ADDENDUM NO. 1

PROJECT TITLE: Parker Park Community Center Pool Addition
City of Jonesboro
Jonesboro, Arkansas

COMMISSION NUMBER: 2301

DATE OF ISSUE: August 18, 2023

Commission Number
 2301
E103
 Date: August 4, 2023

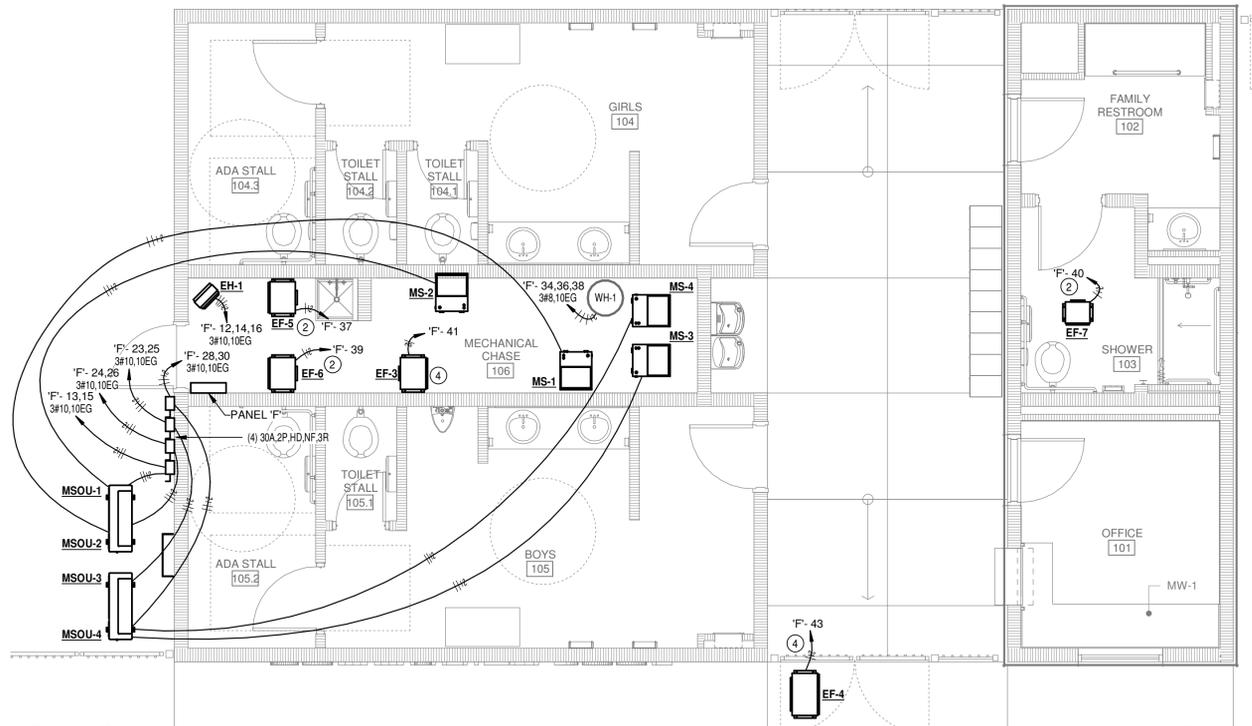
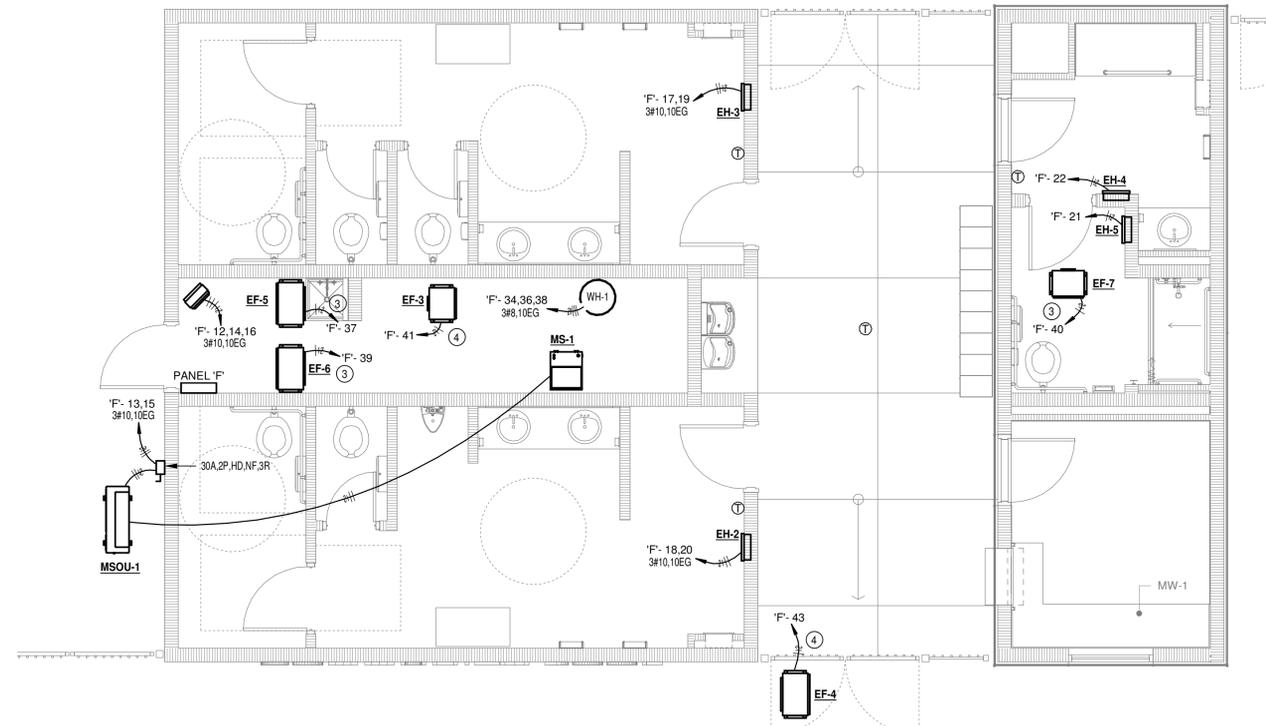
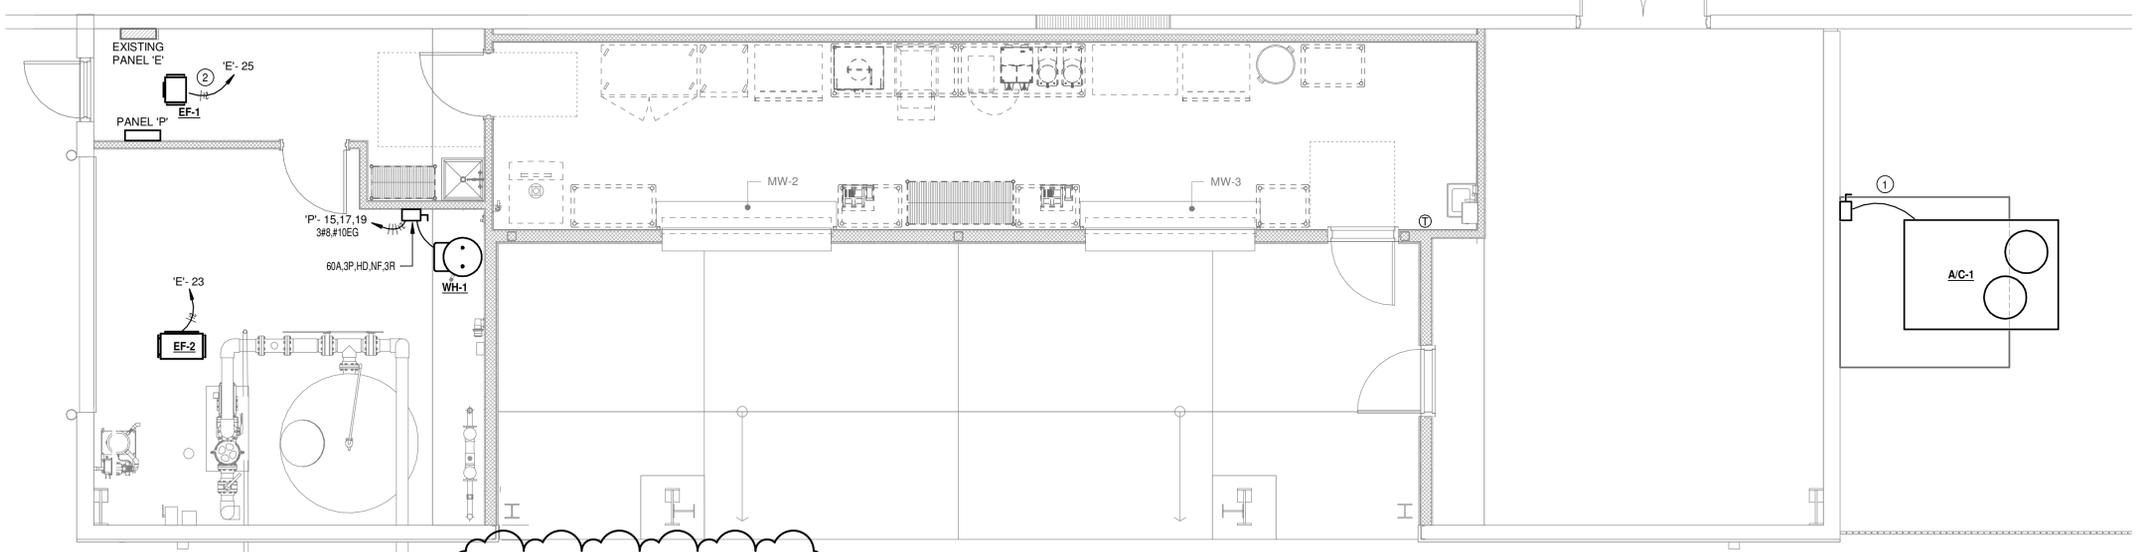
25. Drawings: Sheet E103 – Floor Plan - Systems

- A. Omit Sheet E103 in its entirety. Replace with attached Sheet E103 dated 08.04.23.
Refer to page 47 of this addendum.
